## Front Brake Noise and/or Front Brake Judder

This bulletin replaces S/B 17-016, *Front Brake Noise (2016-17 RDX)*, and S/B 17-049, *Brake Judder (2013–18 RDX)*

Year	Model	Trim	VIN Range
2013-18	RDX	ALL	ALL

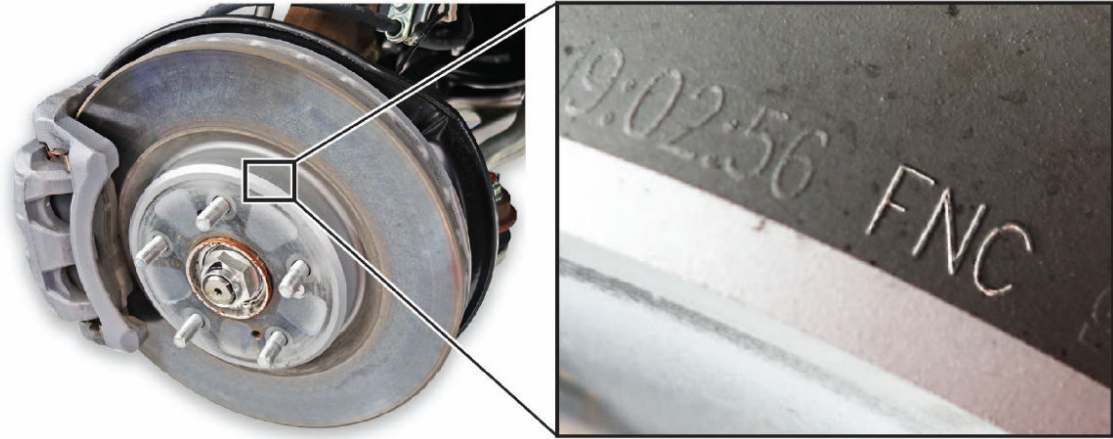
4. Inspect the supplier's manufacturing date code on the brake discs.

- If the brake disc hat stamping date is **May 27, 2015 or later**, and the casting core number in the vent slots is 11 or greater, this bulletin does not apply. Continue with normal system troubleshooting.
- If the brake disc hat stamping date is earlier than **May 27, 2015** or the casting core number is less than 11, go to REPAIR PROCEDURE.

The brake disc hat stamping date may be listed as a Julian date. A Julian date refers to a date that is a combination of the current year and the number of days since the beginning of the year. In which case, May 27, 2015 will be 15147.

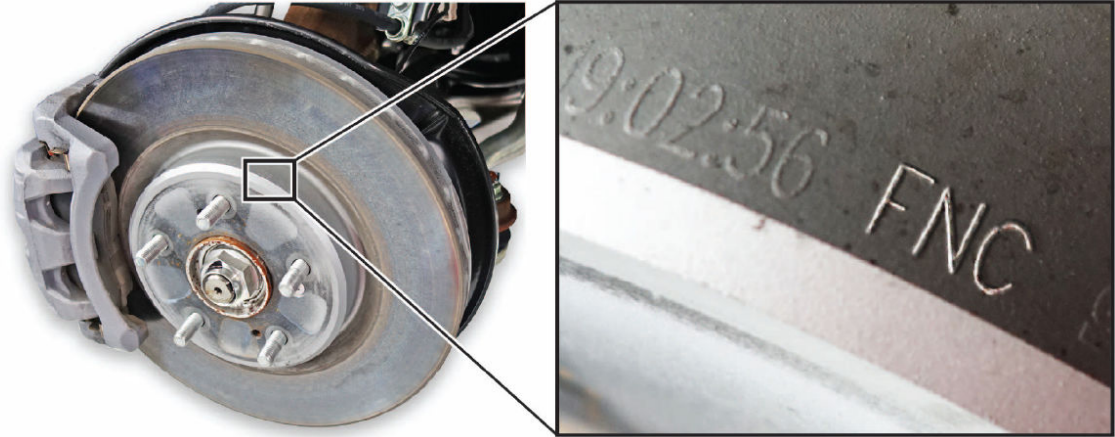
1. With the vehicle on a lift, remove both front wheels.
2. Check if the vehicle has FNC rotors.

- Keep in mind replacement front discs now come with Ferritic Nitrocarburizing (FNC) surface treatment, which increases surface hardness and corrosion resistance. These discs can not be refinished and must always be replaced when out of specification.
3. Does the vehicle have FNC brake discs?
    - Yes - This bulletin does not apply. Continue with normal system troubleshooting.
    - No - Go to REPAIR PROCEDURE.

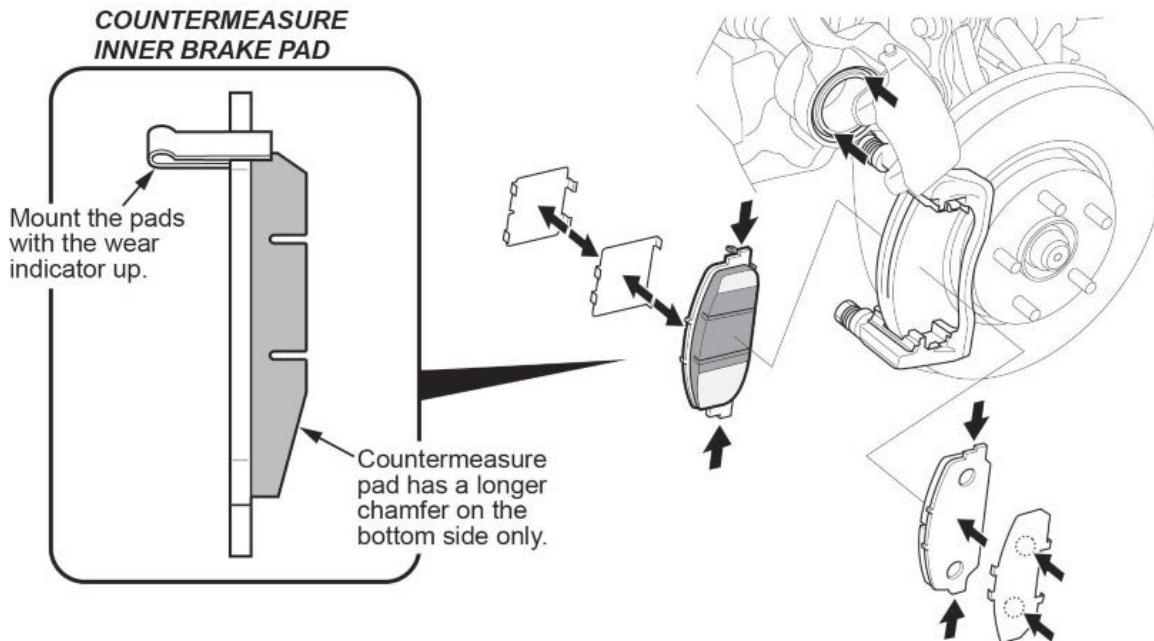
- Make sure the pads are installed correctly. The chamfered inner pads have a wear indicator that should be installed in the inner position with the indicator facing up.
